CITY OF ALBUQUERQUE

Re: Marshall Building
7770 Jefferson NE, Grading Plan
Engineer's Stamp dated 06-25-08 (D-17/D003F)

REVISED
DRAINAGE MANAGEMENT
PLAN FOR:
JOURNAL CENTER

RE: YOUR LETTER DATED 10/5/95, MARSHALL BUILDING/HOLIDAY INN
PYRAMID DRAINAGE ISSUE (D17-D3X).

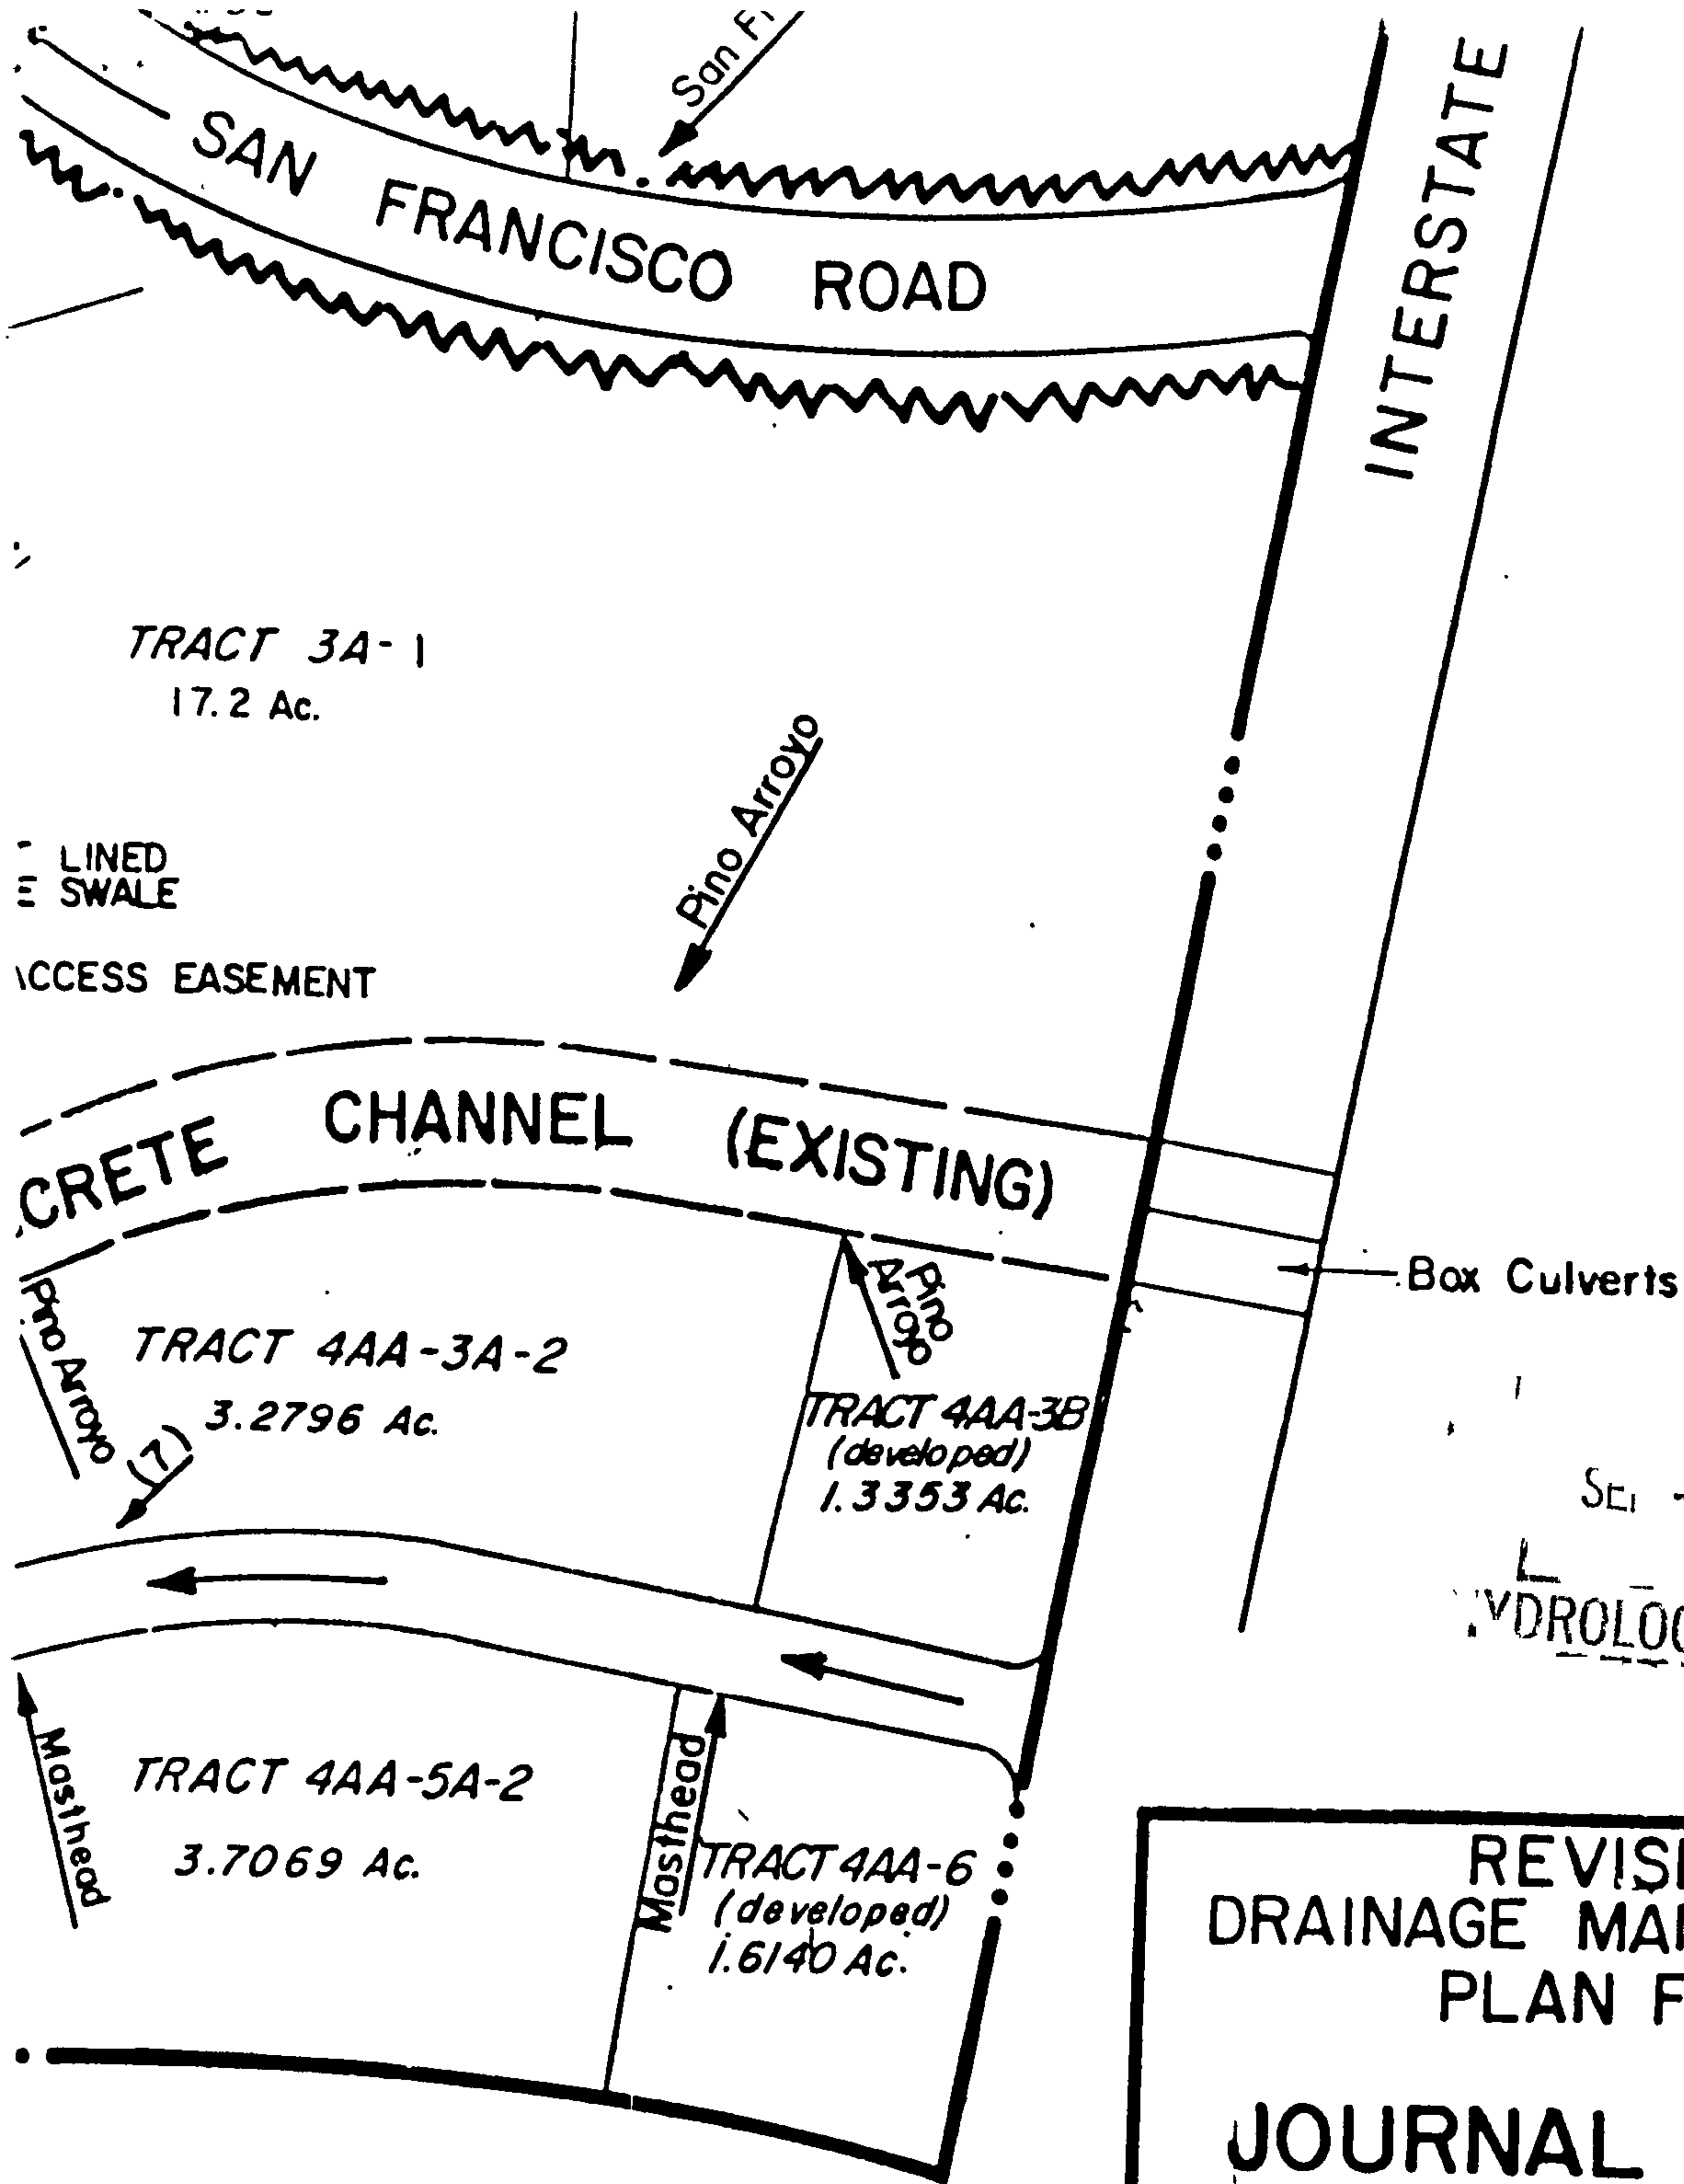
Our approval of the Holiday Inn Pyramid Plaza Pavilion Drainage Report by Tom Mann was based on the Marshall Building's drainage report prepared for your property by Jeff Mortensen and Associates on March 9, 1989. Mr. Mortensen's report contained two sheets, the first sheet was the grading and drainage plan and the second sheet provided the calculations, text and an off site basin map. The plan and the calculations showed a potential off-site flow from the east of 17 cfs from undeveloped land. The calculations also showed that they would diminish the off-site basin and the flow rate reduced to 11 cfs when the basin (Pavilion) was developed. The text on the plan states "When developed, a portion of the off-site flow will be allowed to drain into the project site. This discharge rate is calculated to be 11 cfs, based upon the accompanied off site basin map".

Mr. Mann's plan upgraded the existing drainageway on the Holiday Inn site to convey the Pavilion's flow. The Pavilion site will contribute approximately 3.2 cfs to the rundown. The 3.2 cfs is significantly less than the allowable 11 cfs identified by the Marshall Building plan.

Accordingly because the discharge is following the Marshall Building Drainage Report and the fact that the drainage easement is private on the Marshall Building site, the City does not acknowledge or accept any liability in this matter.
